MINERALS PROGRAM INSPECTION REPORT
PHONE: (303) 866-3567

MINE NAME: Three Bells Pit	MINE/PROSPECTING ID#: M-1979-191	MINERAL: Sand and gravel	COUNTY: Larimer
INSPECTION TYPE: Surety Release Inspection	INSPECTOR(S): Amy Eschberger	INSP. DATE: July 16, 2020	INSP. TIME: 10:00
OPERATOR: Martin Marietta Materials, Inc.	OPERATOR REPRESENTATIVE: Julie Mikulas	TYPE OF OPERATION: 112c - Construction Regular Operation	
REASON FOR INSPECTION: Surety Release Requested	BOND CALCULATION TYPE: Complete Bond	BOND AMOUNT: \$3,294,000.00	
DATE OF COMPLAINT: NA	POST INSP. CONTACTS: None	JOINT INSP. AGENCY: None	
WEATHER: Clear	INSPECTOR'S SIGNATURE: 	SIGNATURE DATE: July 28, 2020

This was a surety release inspection of the Three Bells Pit (Permit No. M-1979-191) conducted by Amy Eschberger of the Division of Reclamation, Mining and Safety (Division) in response to a Full Release Request (SL-2) filed with our office on July 1, 2020. The public comment period for SL-2 closed on July 17, 2020. During this period, the Division received three objections to SL-2 (see enclosed letters), including from the Division of Water Resources (DWR), from Mike DiTullio representing the landowners River Bluffs Ventur

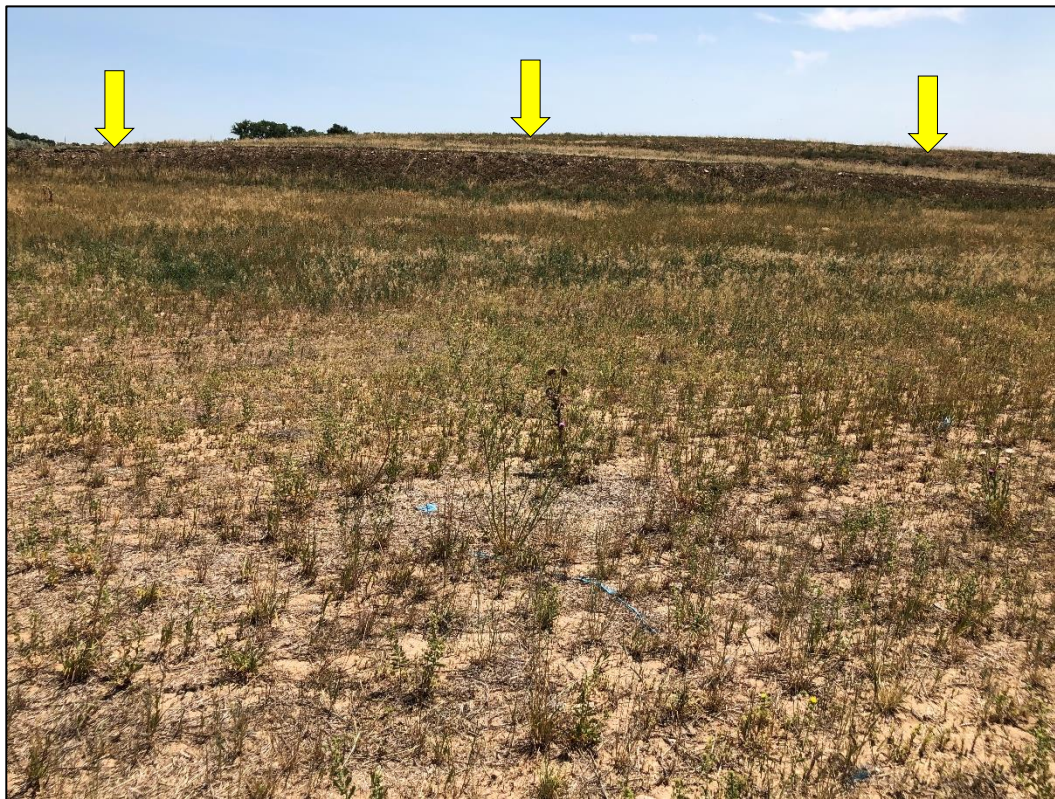
Photo 80. View looking east toward large overburden stockpile (indicated) left in area north of Veldman reservoir, graded to a stable configuration and well vegetated. Additional weed management is required in this area, particularly for Canada thistle, field bindweed, and downy brome. Additional interseeding may also be necessary.

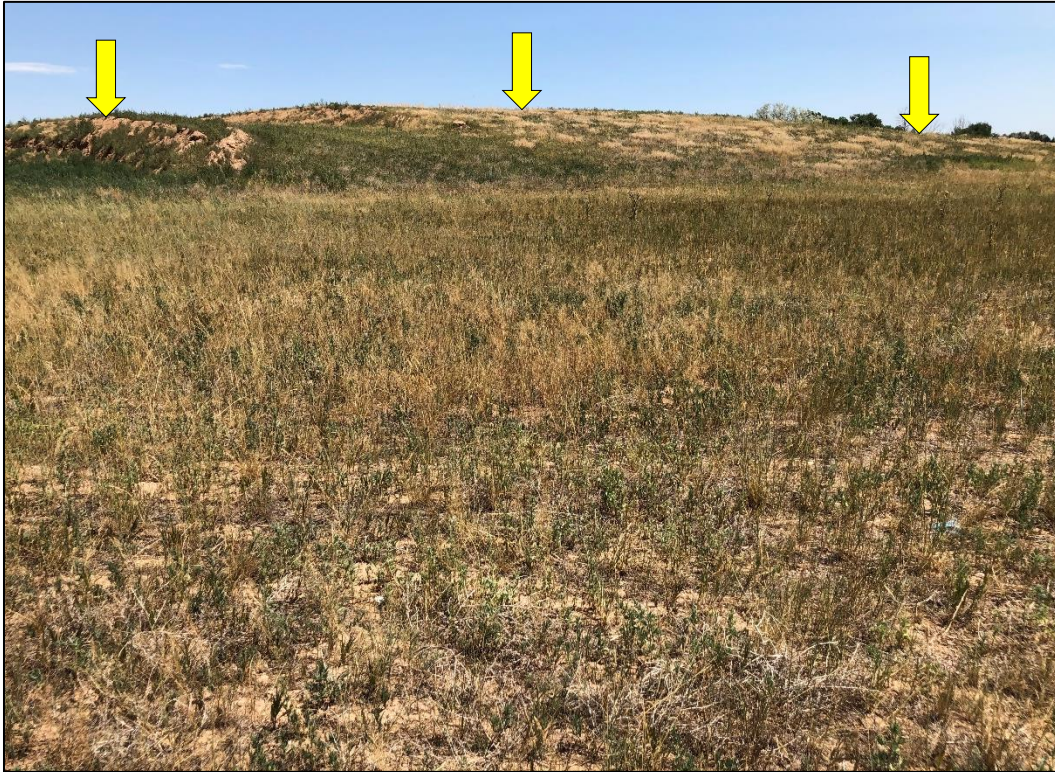
Photo 81. View looking northeast toward large overburden stockpile (indicated) left in area north of Veldman reservoir, graded to a stable configuration and well vegetated. This area has good grass establishment. However, additional weed management is required, particularly for Canada thistle, field bindweed, and downy brome.
